MR. RADHIKA NARAIN thought that Mr. Schönemann's conclusions were of great practical significance. He was fully at one with him in attaching much importance to the main feature of the suggested design for a distributary head regulator consisting of a raised crest and a rising gate sill. He had to confess, however, that he could not always follow the writer in the theoretical side of his paper. To begin with, it appeared that Mr. Kennedy's theory of silt transportation, as stated succinctly by Mr. Higham, included by inference M. Dupuit's theory of the relative velocities of contiguous currents. If T represent the silt transporting power of a channel, V_m the mean velocity, V_o and V_d the surface and bottom velocities, d the depth, and V_r the difference in the relative velocities of two

CORRESPONDENCE.

Fig. 1

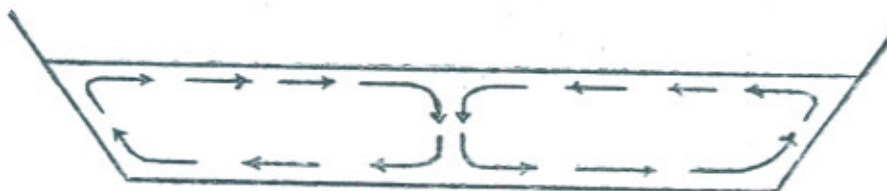
Mr. Gibb appeared to consider that this action extended well out into the stream, the downward current being near the centre, and the current along the bed traversing nearly the whole half width of the channel as sketched in Fig 1.

If this was indeed the case there was much to be said for Mr. Gibb's theories, but he knew of no evidence that this did actually occur. On the other hand, the known absence of marked silting along the sides, or scour in the centre, was evidence against it. The experiments quoted by Mr. Gibb, and illustrated in his Fig. 6,* also failed to convey conviction, since they did not give a most important dimension, namely, the total width of channel experimented on and the width throughout which float observations were made.

Fig. 2.

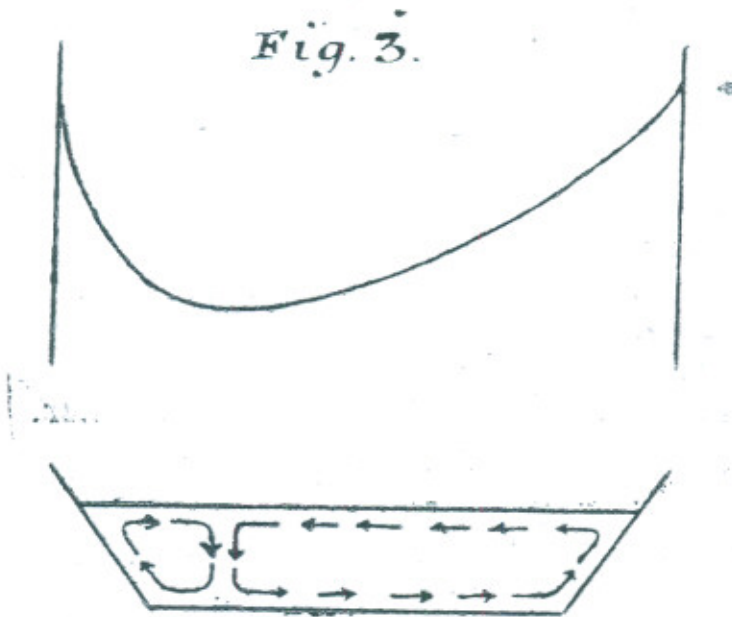
His own view, unsupported, it was true, by any experiments, was that these transverse currents existed only in a small portion of the cross section close to the bank as shown in Fig. 2.

the intensity of the downward current being probably greatest at a short distance away from the toe of the side slope, and reducing gradually to nothing at a relatively small distance from the bank, and if this view was correct, transverse currents might for practical purposes be considered as non-existent, since their effect on silt distribution would be negligible. It should be borne in mind that these currents would be due entirely to the effect of rugosity combined with the shallow water near the bank.

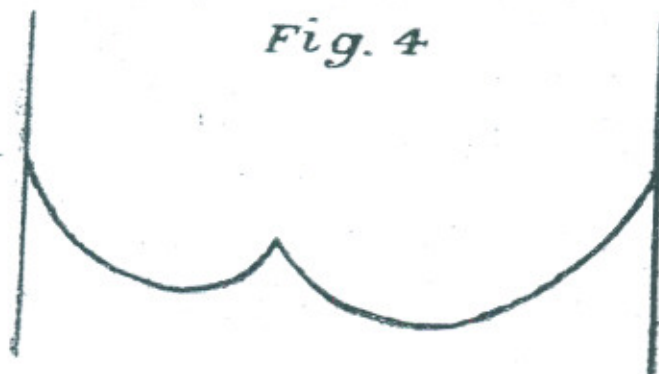
Mr. Gibb appeared to consider that by increasing the velocity of that portion of the stream which was to enter the distributary head, silt would be driven away from it; his idea being apparently that the position of the point of maximum

velocity was shifted towards the distributary side of the channel, and that the point at which downward flow occurred would be correspondingly shifted, as shown in Fig. 3.

This view he contested as a consequence of his opinion that the transverse circulating currents were purely local and did not extend far from the banks.

Fig. (a)

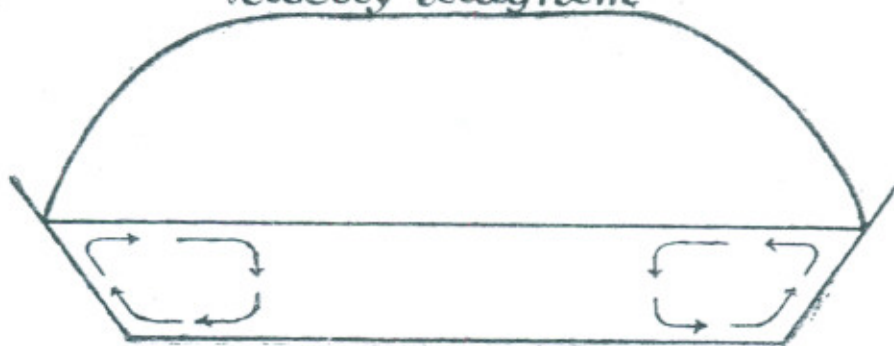
Mr. Elsdon's explanation of the cause of cross currents was thus incorrect. He admitted however the existence of the currents in question, and for their true cause he could only refer him again to Appendix B of his paper. He agreed with Mr. Elsdon that the cross circulation in straight channels might be, and often was, normally confined to relatively narrow marginal strips on either side. This would occur when the horizontal velocity diagram was flat in the middle as in Fig. (a), while a velocity

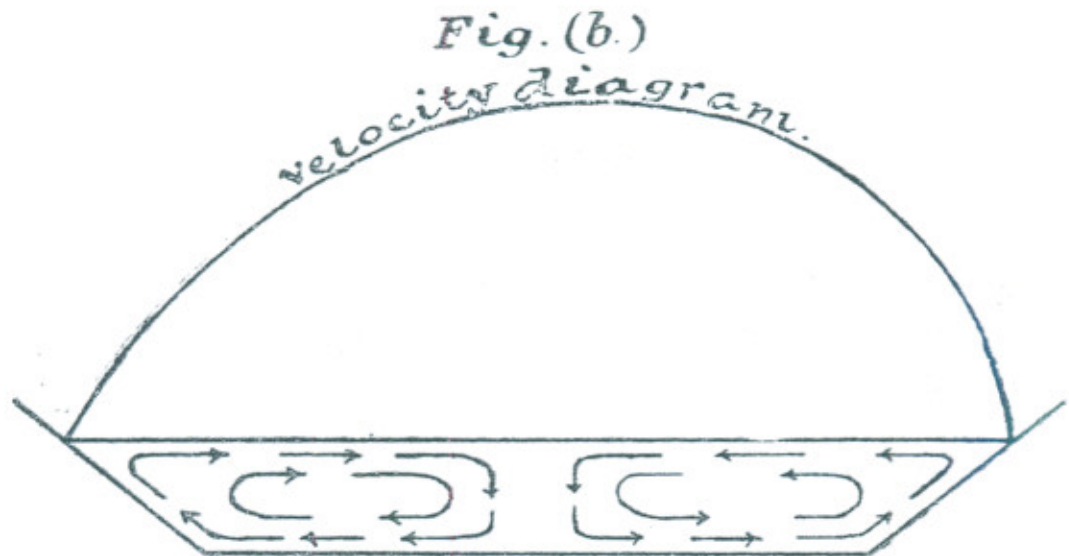
diagram like that in Fig. (b) would cause the circulation to extend

towards the middle of the stream. This followed from the explanation given in Appendix B. It did not, however, make any difference in the case of the distributary head, because, according to the principle he had suggested, the head would be designed so as to impose on the approaching stream whatever direction and strength of circulating cross currents was desired. For instance the section of stream and velocity diagram just upstream of a distributary head for taking a small silt charge would be like Fig. (c).

FIG. III.

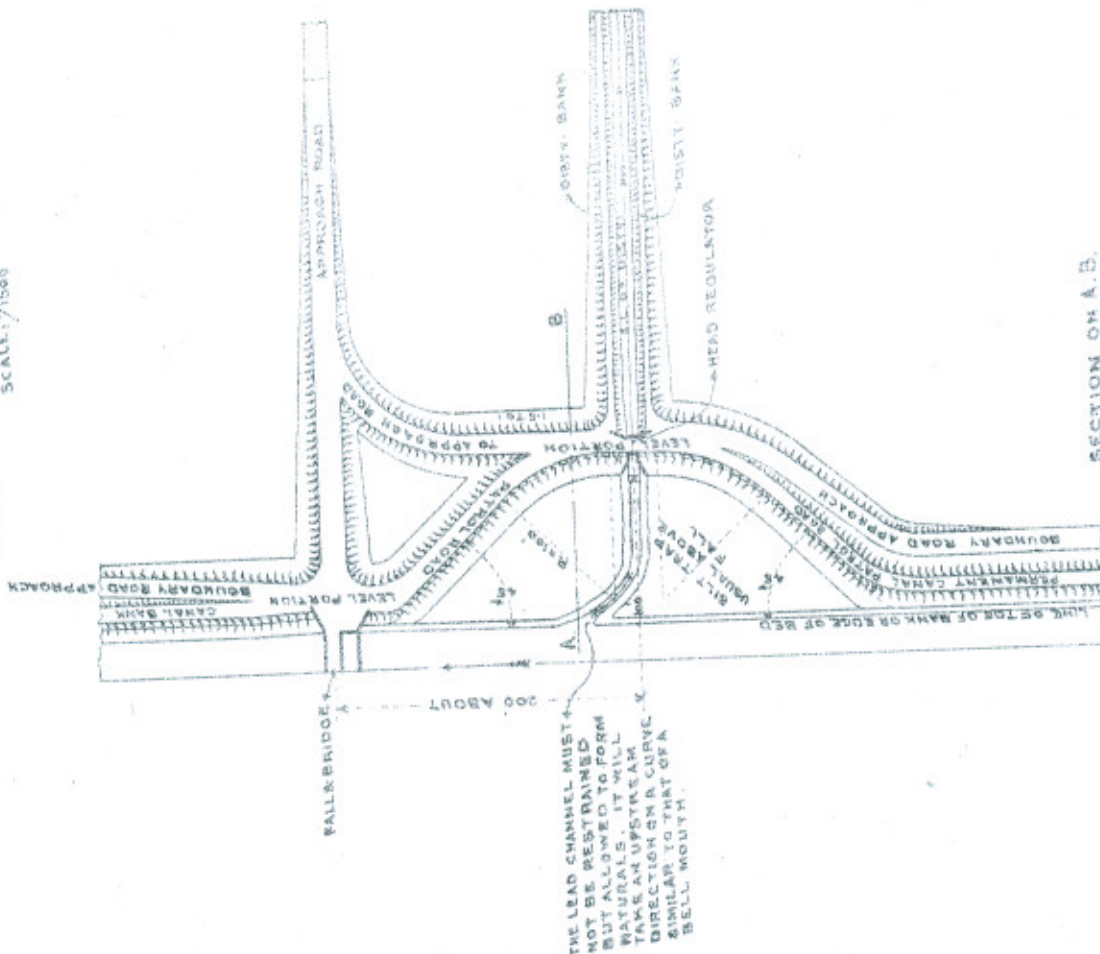
To fix ideas, a sketch had been prepared of such a piped head (Fig. III); it was drawn for a distributary from a canal, but by suitably modifying the dimensions it would suffice for a water-course leaving a distributary.
